Joint Mequon-Thiensville Bike and Pedestrian Way Commission
Thursday, February 4, 2021
8:00 AM
Virtual Meeting

TO: Joint Mequon-Thiensville Bike and Pedestrian Way Commission
FROM: Kristen Lundeen, Director of Public Works/City Engineer
DATE: January 14, 2021
SUBJECT: Highland Road Bike/Pedestrian Spur

Highland Road Bike/Pedestrian Spur

Attachment: Highland Road Right-of-Way (5814 : Highland Road Bike/Pedestrian Spur)

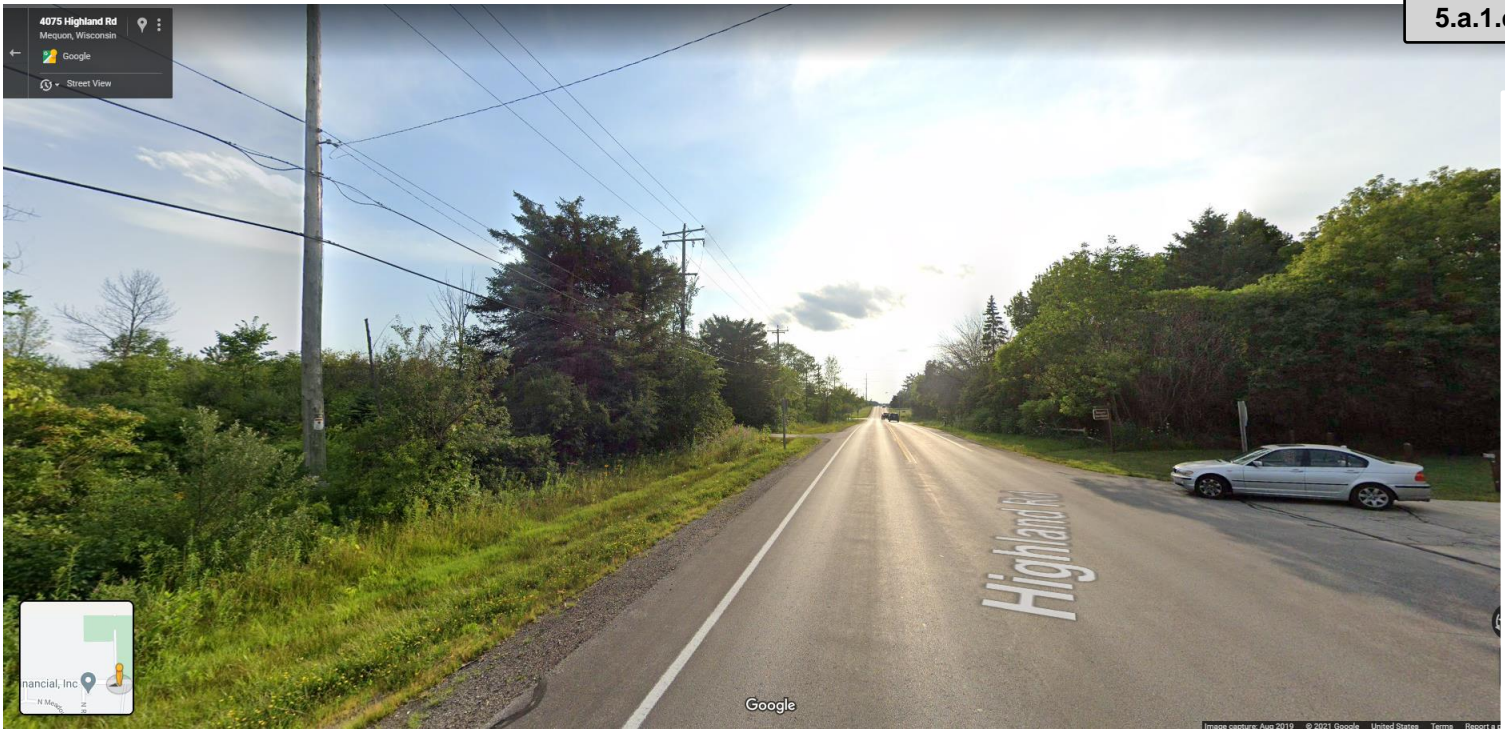
Note:

- Proposal does not contemplate connection to the east driveway

Note:

- Design should address the impact to existing landscaping and buffer

Note:

- The right-of-way may not be sufficient to allow a 10' path with two 1' shoulders and maintain existing drainage
- Modifying drainage may impact more than the right-of-way
- Drainage must be included in the design of the off-road path

Note:

- The right-of-way may not be sufficient to allow a 10' path with two 1' shoulders and maintain existing drainage
- Modifying drainage may impact more than the right-of-way
- Drainage must be included in the design of the off-road path

Note:

- The right-of-way may not be sufficient to allow a 10' path with two 1' shoulders and maintain existing drainage
- Modifying drainage may impact more than the right-of-way
- Drainage must be included in the design of the off-road path

Note:

- Design should address the impact to existing landscaping and buffer
- The right-of-way may not be sufficient to allow a 10' path with two 1' shoulders and maintain existing drainage
- Modifying drainage may impact more than the right-of-way
- Drainage must be included in the design of the off-road path

Note:

- The right-of-way may not be sufficient to allow a 10' path with two 1' shoulders and maintain existing drainage
- Modifying drainage may impact more than the right-of-way
- Drainage must be included in the design of the off-road path

Note:

- Potential for utility conflict at the intersection.
- The design for the proposed crosswalk should consider existing intersection design.
- The right-of-way may not be sufficient to allow a 10' path with two 1' shoulders and maintain existing drainage
- Modifying drainage may impact more than the right-of-way
- Drainage must be included in the design of the off-road path

Note:

- Potential for utility conflicts.
- The design for the proposed crosswalk should consider existing intersection design.
- The right-of-way may not be sufficient to allow a 10' path with two 1' shoulders and maintain existing drainage
- Modifying drainage may impact more than the right-of-way
- Drainage must be included in the design of the off-road path

Note:

- Potential for utility conflicts.
- The right-of-way may not be sufficient to allow a 10' path with two 1' shoulders and maintain existing drainage
- Modifying drainage may impact more than the right-of-way
- Drainage must be included in the design of the off-road path
